GULF STATES UTILITIES COMPANY

February 5, 1985
RBG- 20,079
File No. G9.5, G9.19.2
G9.20.6

River Bend Station - Unit 1
Docket No. 50-458

The attached information is being provided as requested by the Nuclear Regulatory Commission's Emergency Preparedness Licensing Branch (EPLB) for it's review and input to Safety Evaluation Report Section 13.1.

FIGURE 13.3-7
 SITE AREA EMERGENCY-
 EMERGENCY ORGANIZATION
 RIVER BEND STATION
 FINAL SAFETY ANALYSIS REPORT

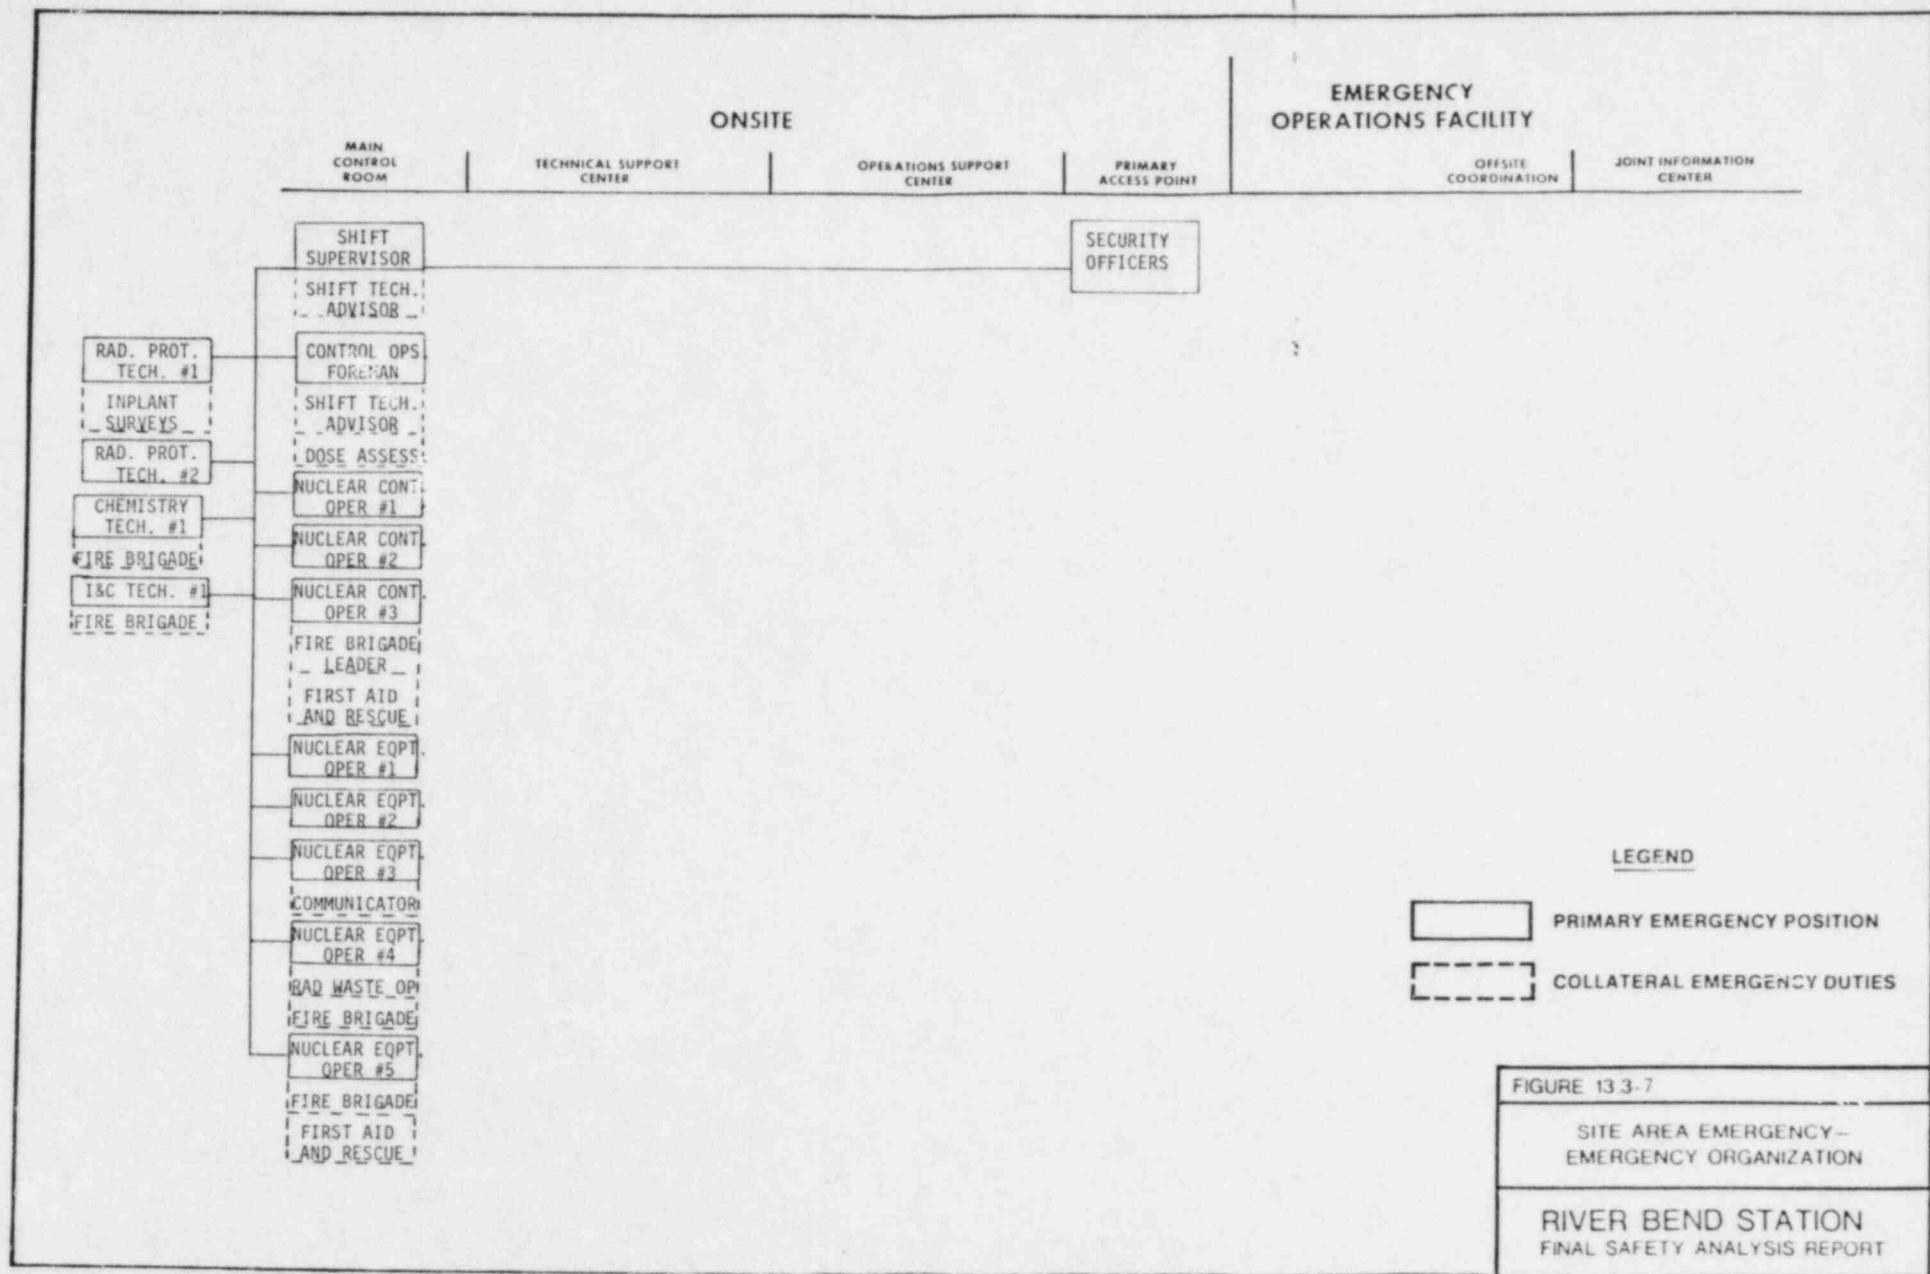
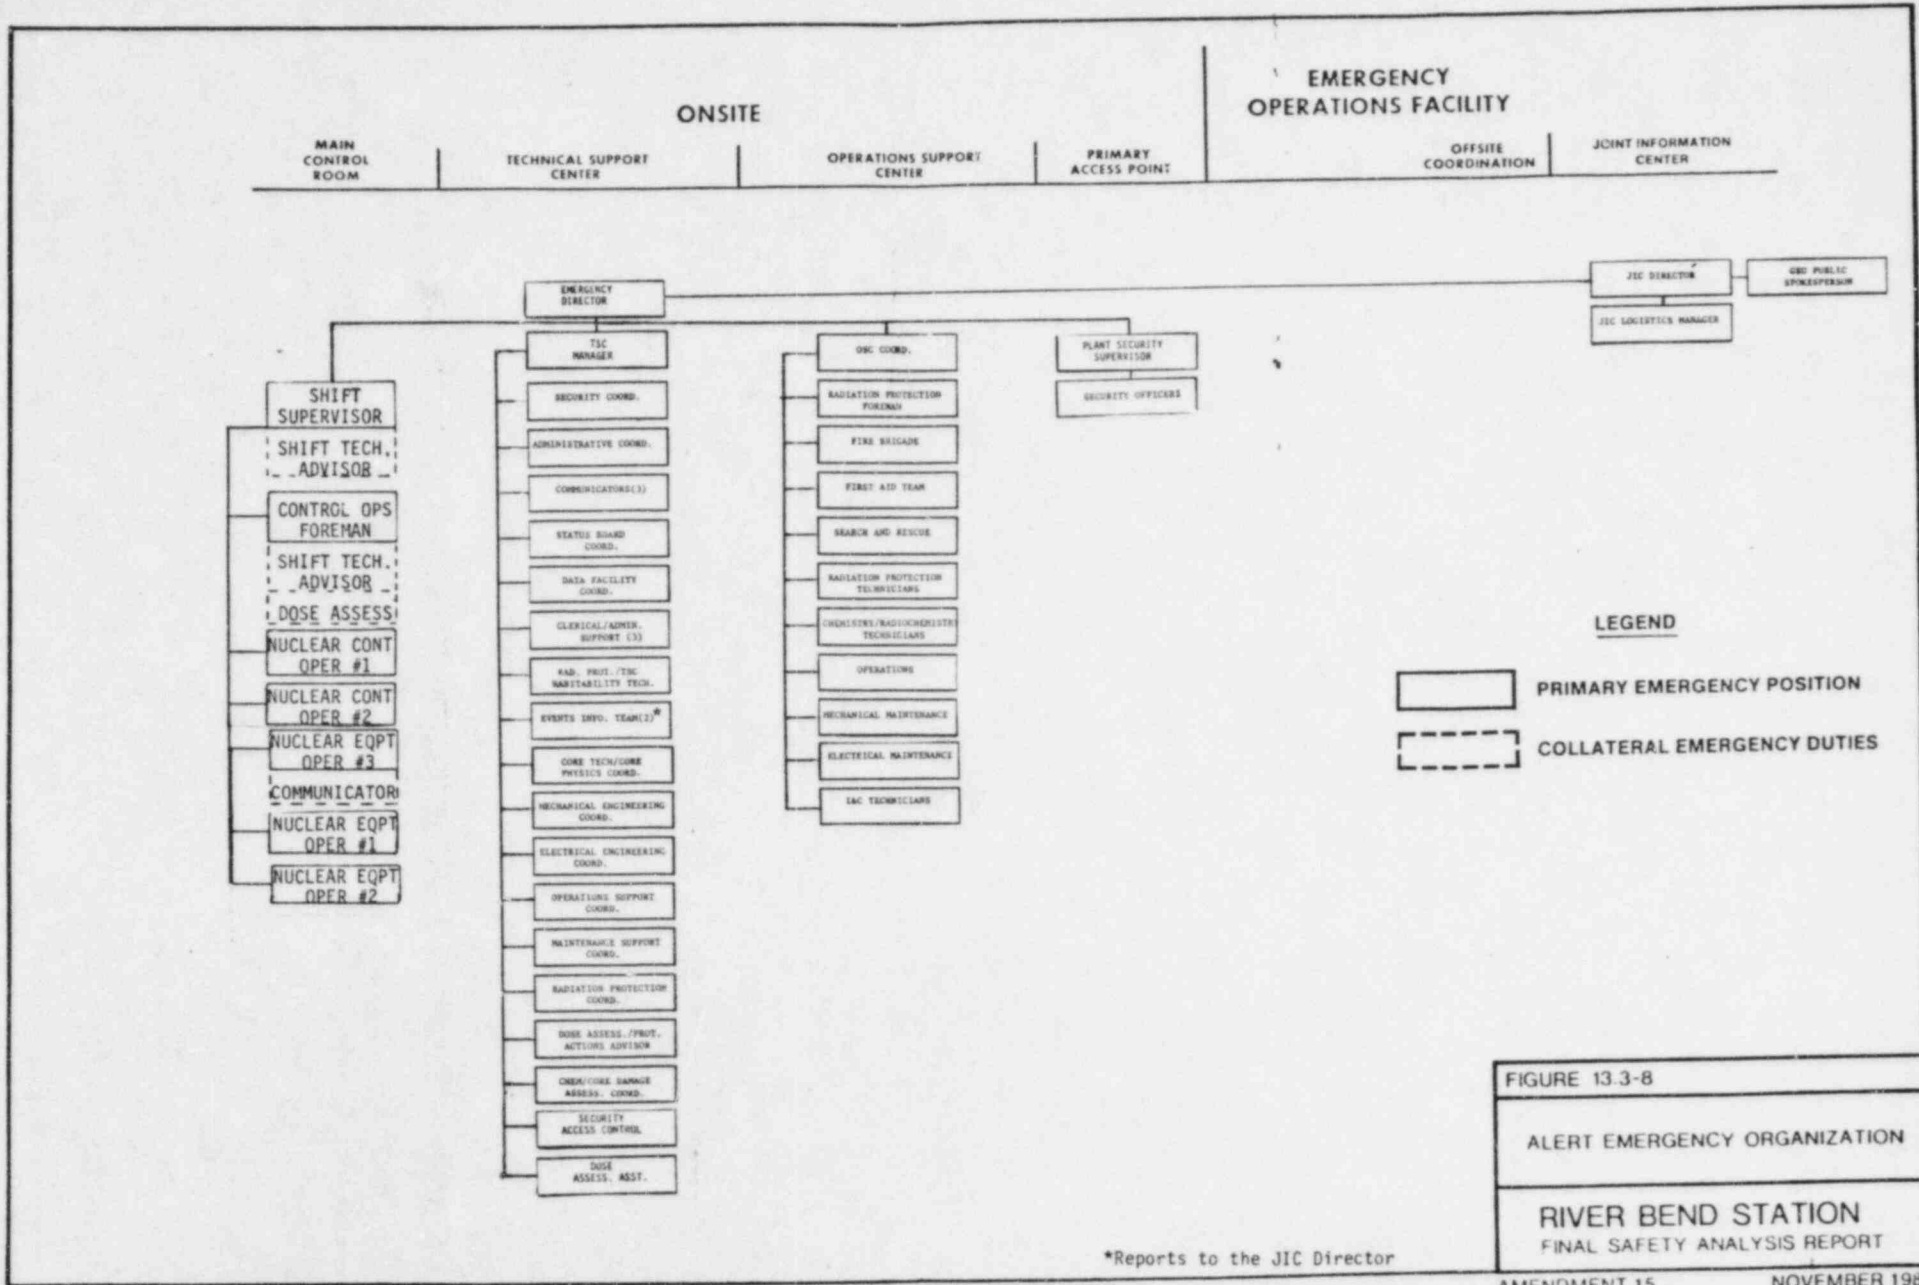
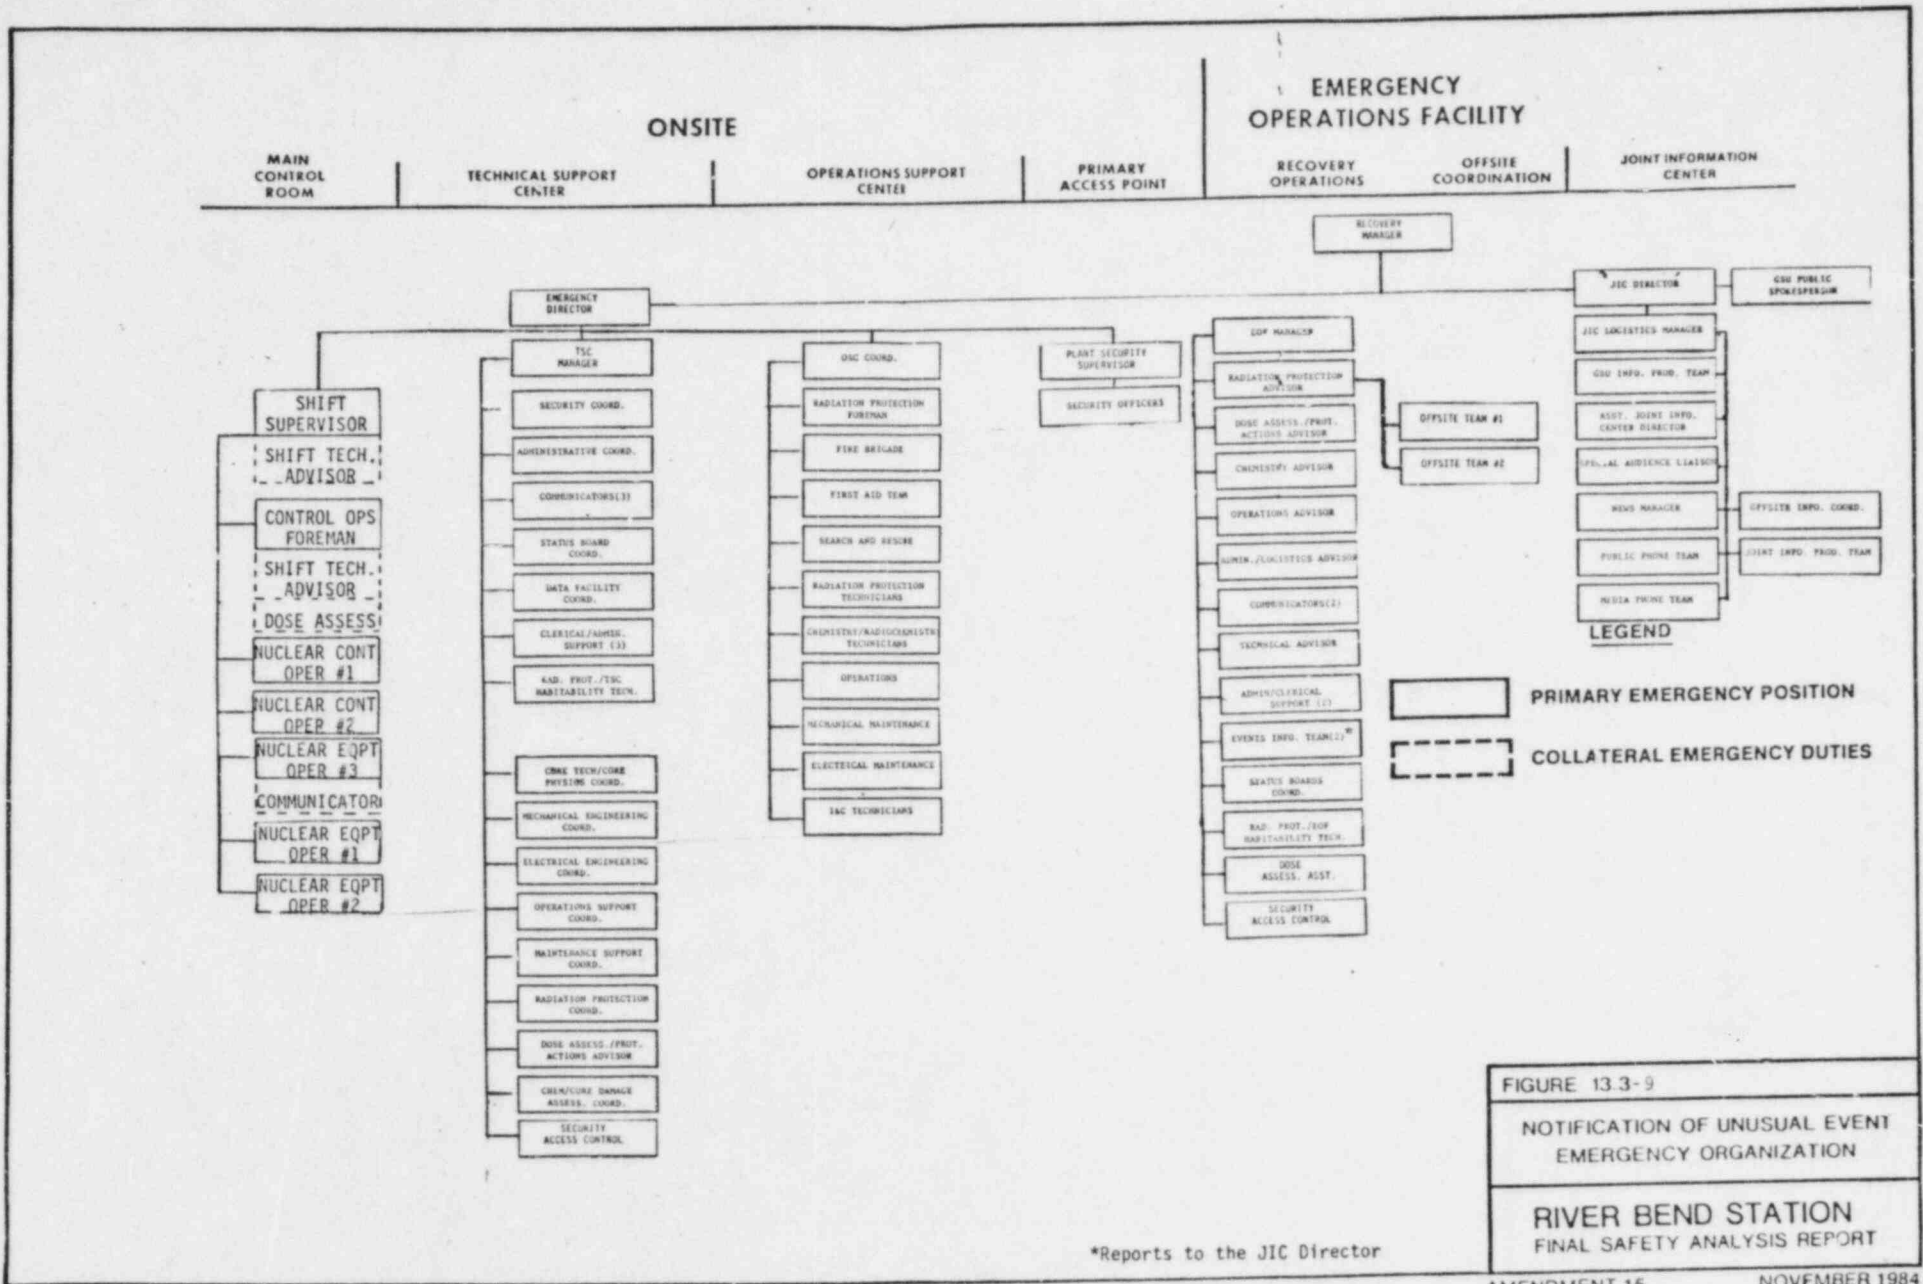
The Shift Technical Advisor's functions are performed by the Shift Supervisor as indicated in Table 13.3-5, Sheet 1, and Figures 13.3-7 through 13.3-10. An additional Radiation Protection Technician No. 3 is available on the operating shift. Health physics training is provided to the on-shift Chemistry Technician to enable him to provide health physics support for access control, personnel monitoring, and general health physics coverage. ~~Tables 13.3-5 and 13.3-6, Figures 13.3-7, 13.3-8, 13.3-9, and 13.3-10, and Appendix A have been revised accordingly.~~
